| <b>Re: Service Campaign Notification</b><br><b>Model: eSprinter</b><br><b>Model Year: 2024</b><br><b>Install NACS Adapter Information Label</b> | Date: February 2025  |

| <b>Campaign No.:</b>  | <b>Campaign Desc.:</b>  | <b>NHTSA ID:</b> | <b>Install NACS Adaptor Info Label</b> |
| 2025020008  | V3EAUFLAD   | N/A              |  |

D00.00-A139-79

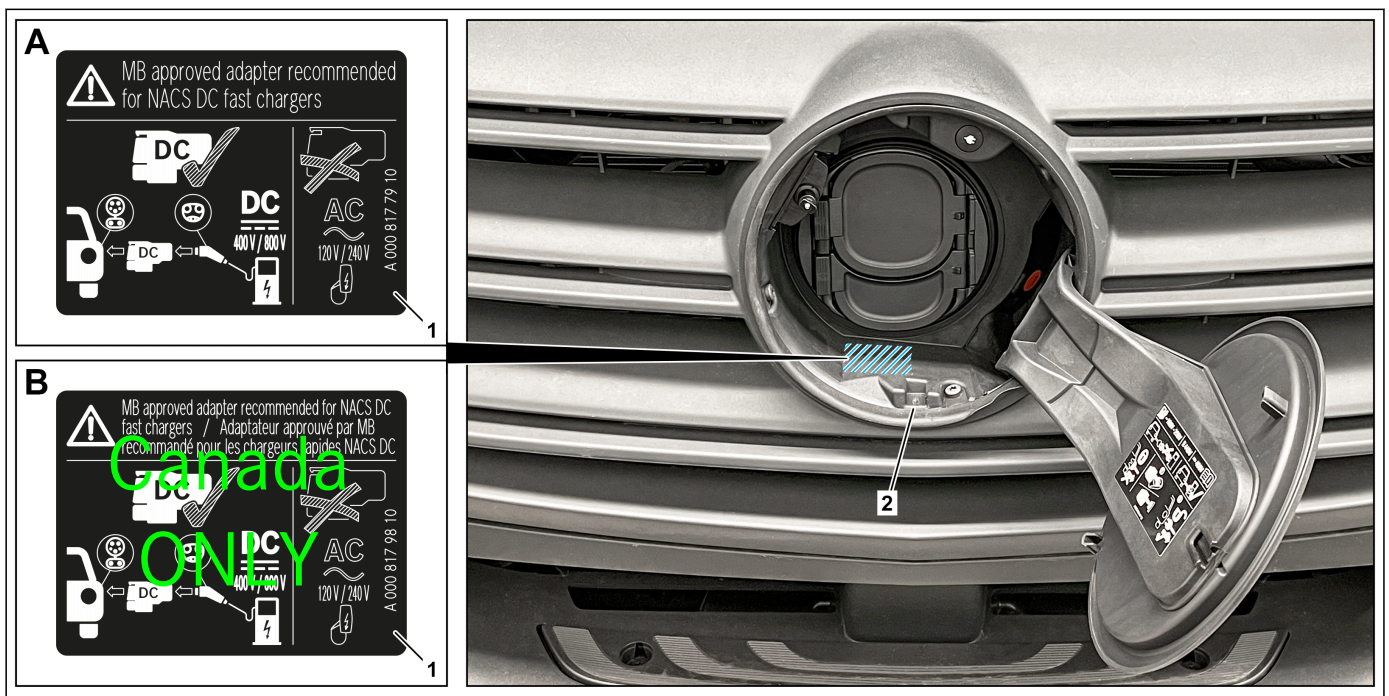
| 3  | Clean socket recess (2) in hatched area. |   |  |
| 4  | Attach new information label (1).        |  <p>The bonding area at the socket recess (2) must be absolutely free of dust and grease. Otherwise, there may be adhesion problems.</p>  Code ZU8 (National version for USA) |  |
|  |  | <p>See picture "B".</p>  <p>Position information label (1) to be clearly legible.</p>  |  |
